Paul and Narelle van den Bos believe that SIMTA EIS Stage 1 Traffic and Transport Impact Assessment should be re-done; but this time by competent staff.

SIMTA EIS

Figure 2 Moorebank Av between Newbridge Rd and Heathcote Rd

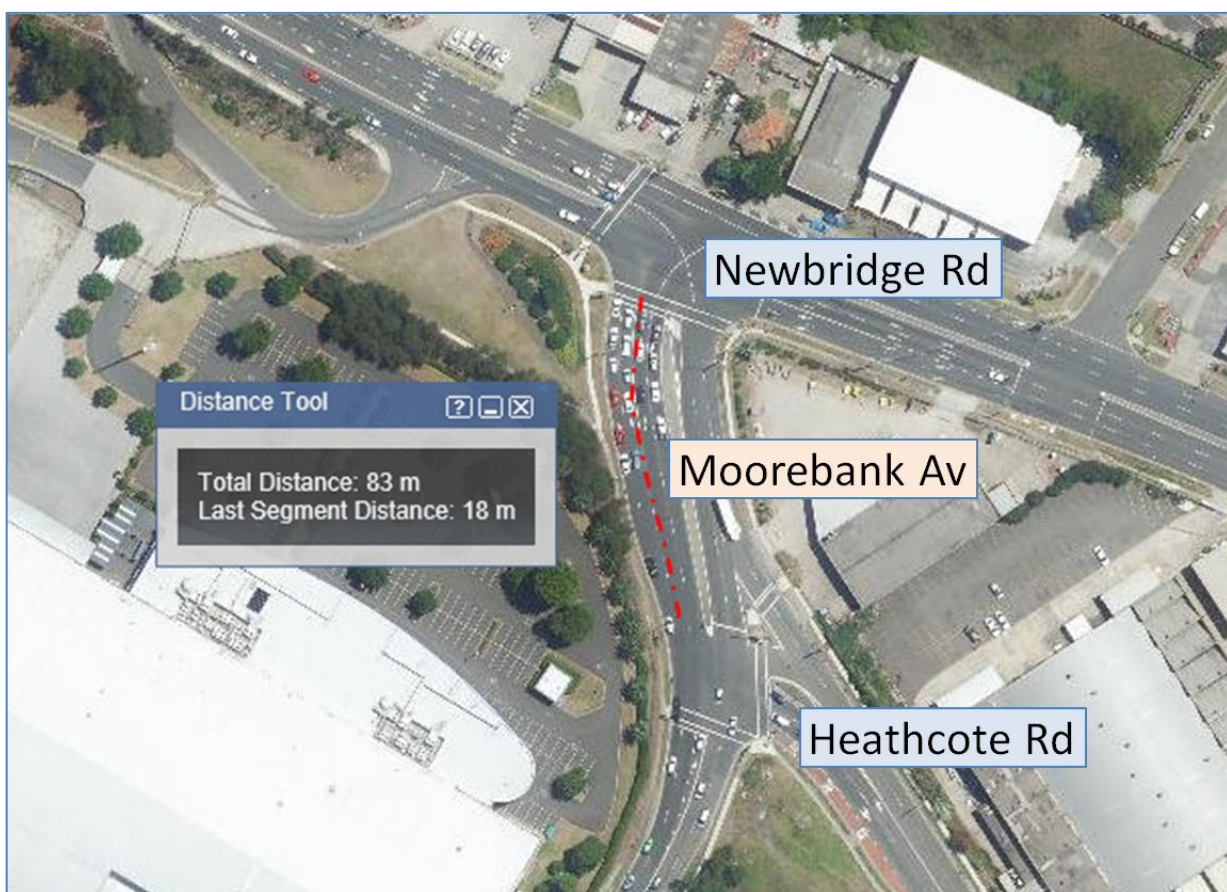
Figure 2 Moorebank Av between Newbridge Rd and Heathcote Rd shows that the distance between Heathcote Rd and Newbridge Rd is 83 m.

These two intersections have been analysed in the MICL and SIMTA EIS documents, and the results are compared.

By inspection, it is obvious that the northbound queue will impact the operation of the Heathcote intersection for a very significant time.

By inspection, it is clear that the queue lengths of these two closely spaced intersections affect the operation of the other intersection.

- The Northbound queue towards Newbridge Rd affects Heathcote Rd intersection for a very significant proportion.
- The southbound queue towards Heathcote Rd, affects the Newbridge Rd intersection for 5% of the time.

Clearly, using the SIDRA isolated intersection software is very inappropriate, because

- the queue backspill is not incorporated, and
- the obvious numerical inconsistencies between outflows and inflows between intersections.

Figure 4-1 Indicative Upgrades at the Moorebank Avenue/Newbridge Road intersection

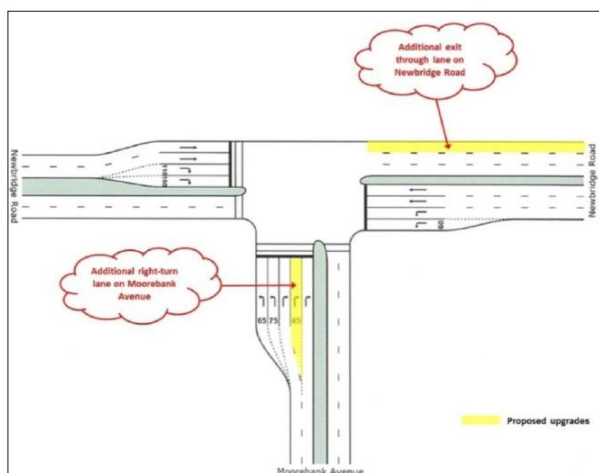
Paul developed two SIDRA-networks containing the Newbridge and Heathcote intersections: (1) the existing base and (2) the improved network, incorporating the potential improvements identified by TfNSW and RMS.

The improved network performs better than the existing network: for a desired speed of 60 km/hr, the average network speeds increase from 6.1 km/hr in the existing network to 7.1 km/hr in the improved network.

Changing the average network speed from 6.1 km/hr to 7.1 km/hr resulting from the potential network improvements identified by TfNSW and RMS, will cost a great deal of taxpayers' money, with only trivial benefits.

Sadly, this again shows that the traffic engineers within the TfNSW and RMS who identified this potential network improvement have clearly forgotten all the fundamentals of traffic engineering theory.
